All seals for this set of drawings are applied to the cover page(s)	Print Date: \$DATE\$	<b>Sheet Revisions</b>			<b>Colorado Department of Transportation</b>		<b>As Constructed</b>		<b>RAIL ANCHOR SLAB/BEAM RAIL/CURB DRAIN DETAILS</b>		Project No./Code
	File Name: Sheet_B-504-V3.dgn	Date:	Comments	Init.	2829 West Howard Place, 3rd Floor Denver, CO 80204 Phone: 303-512-4079 FAX: 303-757-9197	No Revisions:					
	Horiz. Scale: Vert. Scale: As Noted					Revised:	Designer: XXXXXXXX	Structure Numbers: XXXXXXXXXXXXX			
Unit Information Unit Leader Initials					Staff Bridge Branch	Void:	Detailer: XXXXXXXX	Subset Sheets: WXX of XXX			Sheet Number

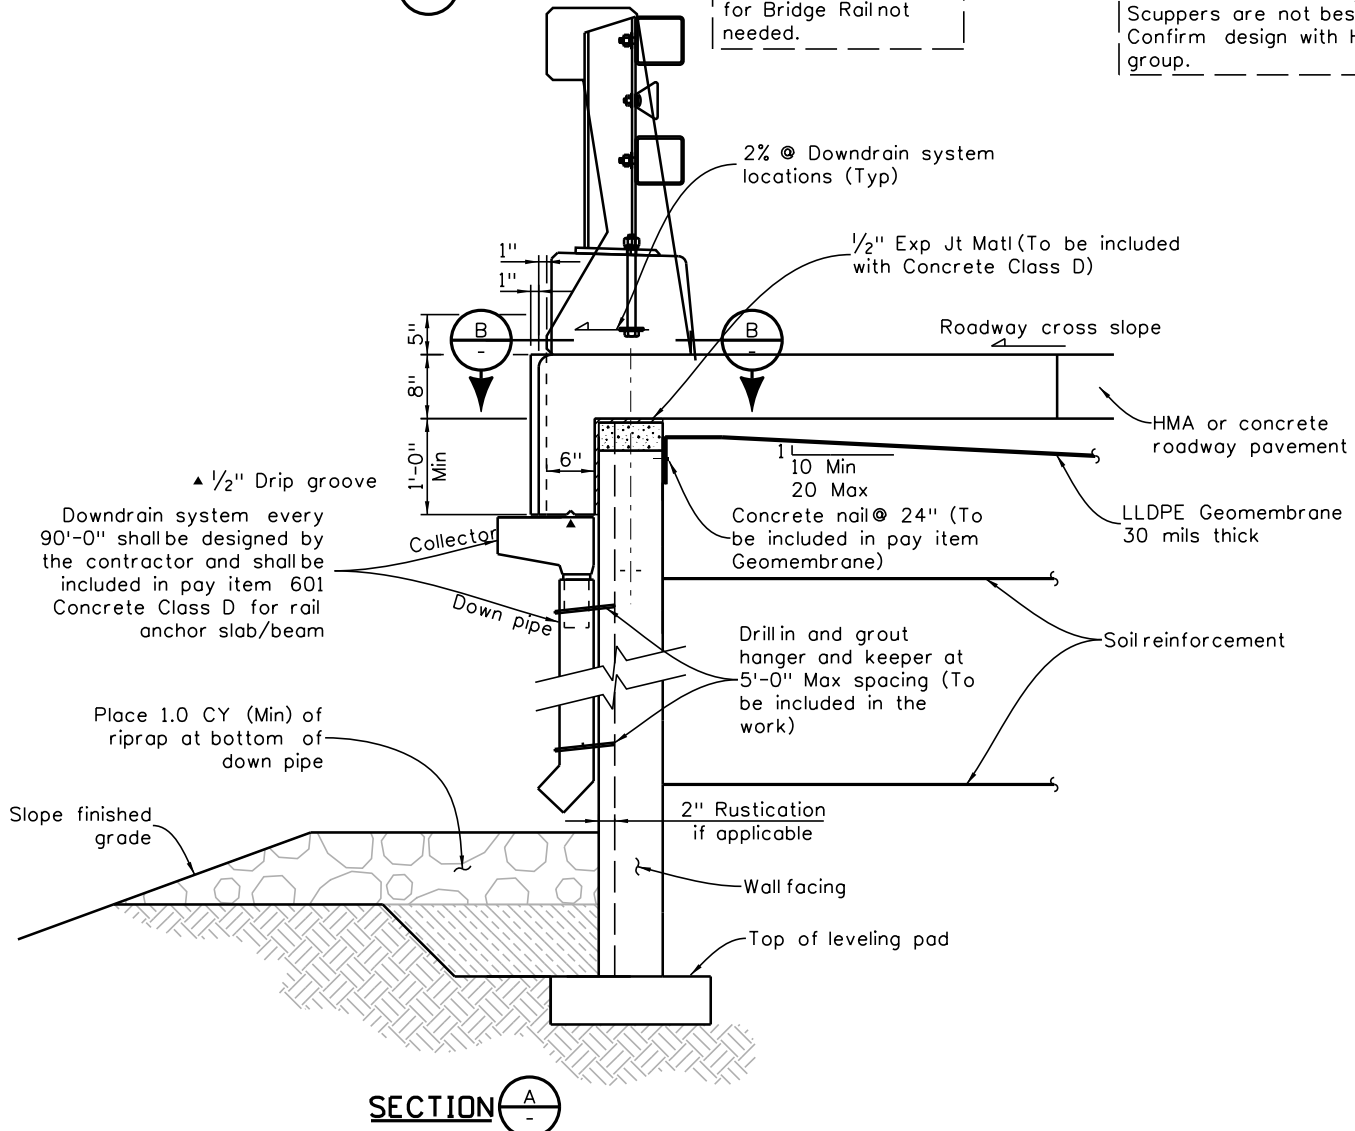
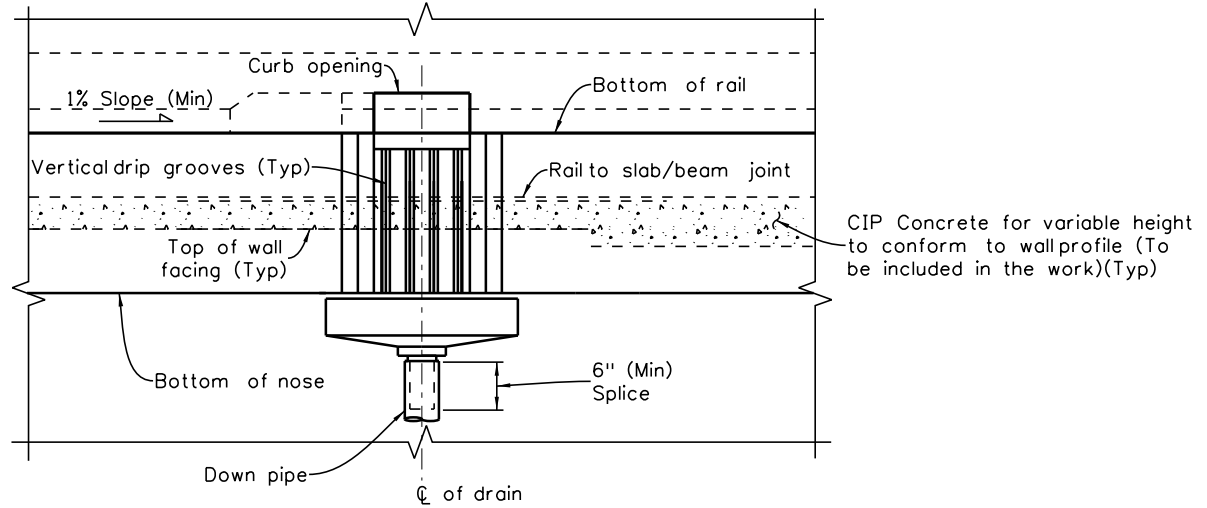
Detailer: Turn off level for Bridge Rail not needed.

Note to Detailer/Designer: Scuppers are not best option. Confirm design with Hydraulics group.
